HISTORIC AND DESIGN REVIEW COMMISSION

Agenda Item No: 1

HDRC CASE NO: 2015-118
ADDRESS: 200 RIVERWALK
LEGAL DESCRIPTION: NCB 405 BLK LOT P-100 (PT OF RIVER WALK)
ZONING: UZROW
CITY COUNCIL DIST.: 1
APPLICANT: Beaty Palmer Architects
OWNER: City of San Antonio, Downtown Operations, a Division of Center City Development Office
TYPE OF WORK: Robert H Hugman statue
REQUEST:

The applicant is requesting a Certificate of Appropriateness for approval to:

1 PLAN
 sc. 1/4" = 1'-0"

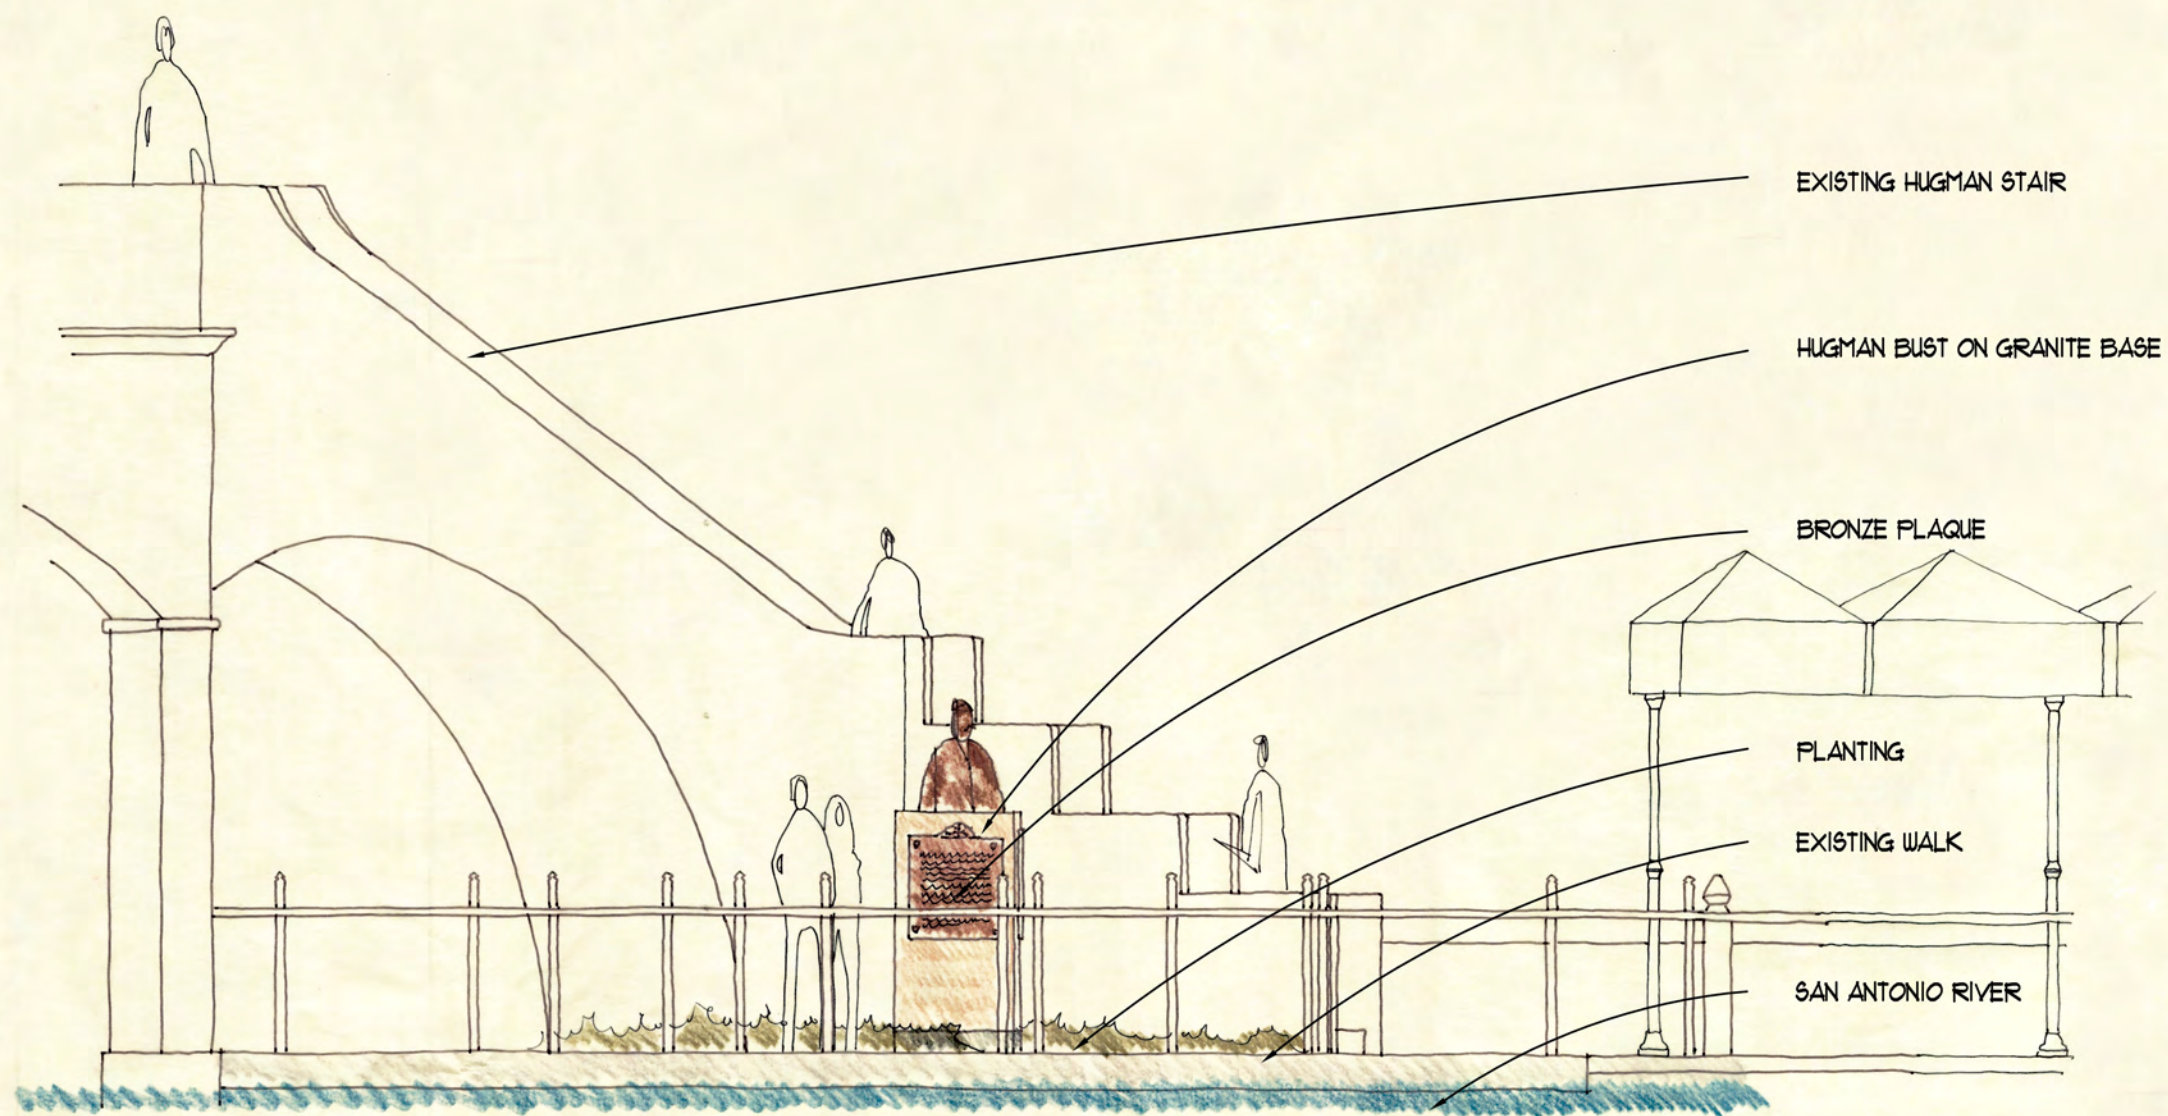
- a. The applicant has proposed to remove an existing planting bed that was installed circa 2011 that is not an original Hugman feature. By removing this, the applicant would be returning to the original, Hugman design, which would be appropriate.

- b. The applicant has also proposed to remove a section of the river wall that's approximately eight (8) inches in height to accommodate a reinforced concrete foundation which will support the granite statue base. The applicant is responsible for complying with any State and Federal regulation regarding the removal of a portion of the river wall.

- e. The applicant is proposing the modify the existing landscaping around the proposed location of the commemorative plaque and bust. The applicant is responsible for complying with the UDC Section 35-673(f) in regards to plant materials.

Staff recommends approval as submitted.

2 **ELEVATION**
 sc: 1/4" = 1'-0"

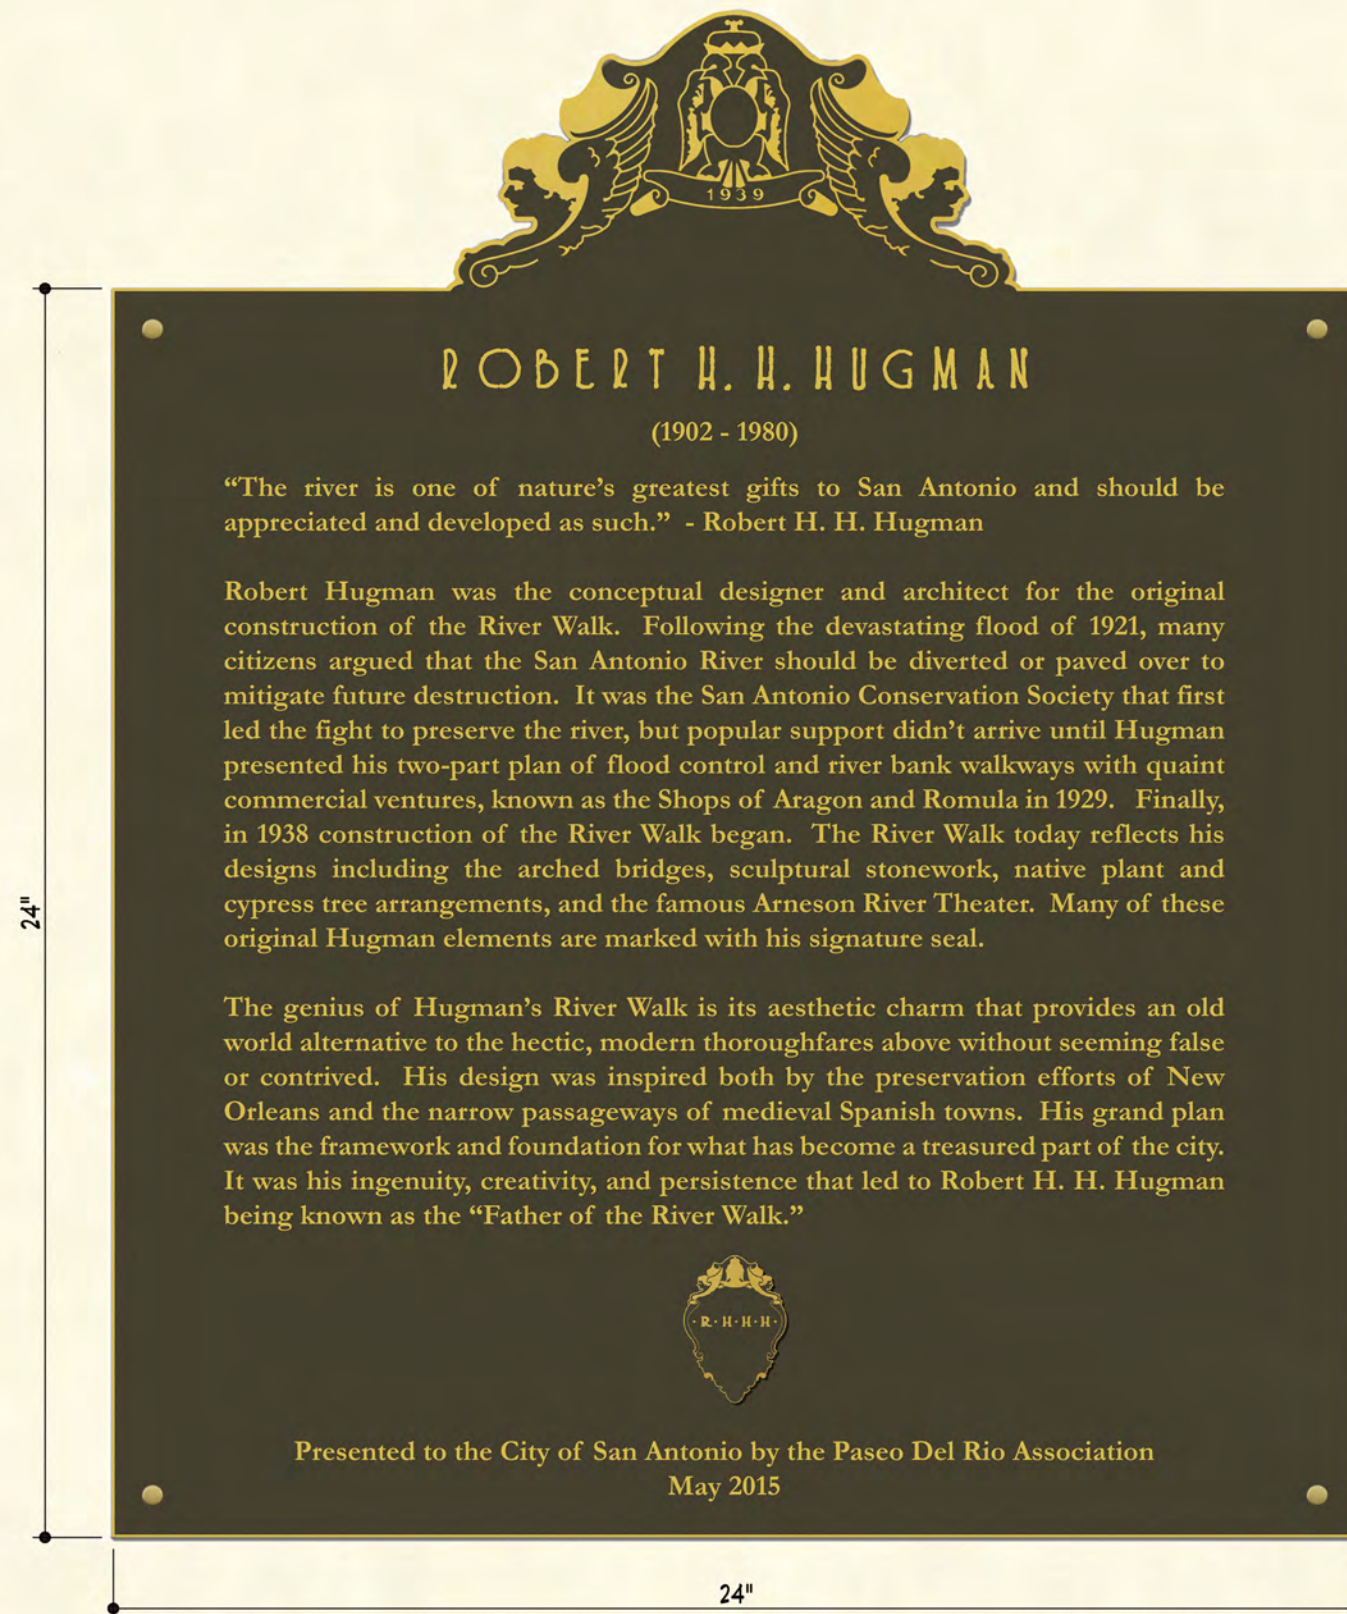
- c. The applicant has proposed to mount the bronzed bust of Robert H. H. Hugman on a granite base. Per the UDC Section 35-673(g) in regards to paving materials, any new materials on or adjacent to the Riverwalk pathway should be clearly distinguishable from those of the Riverwalk. The applicant's proposed to use a granite base is consistent with the UDC.
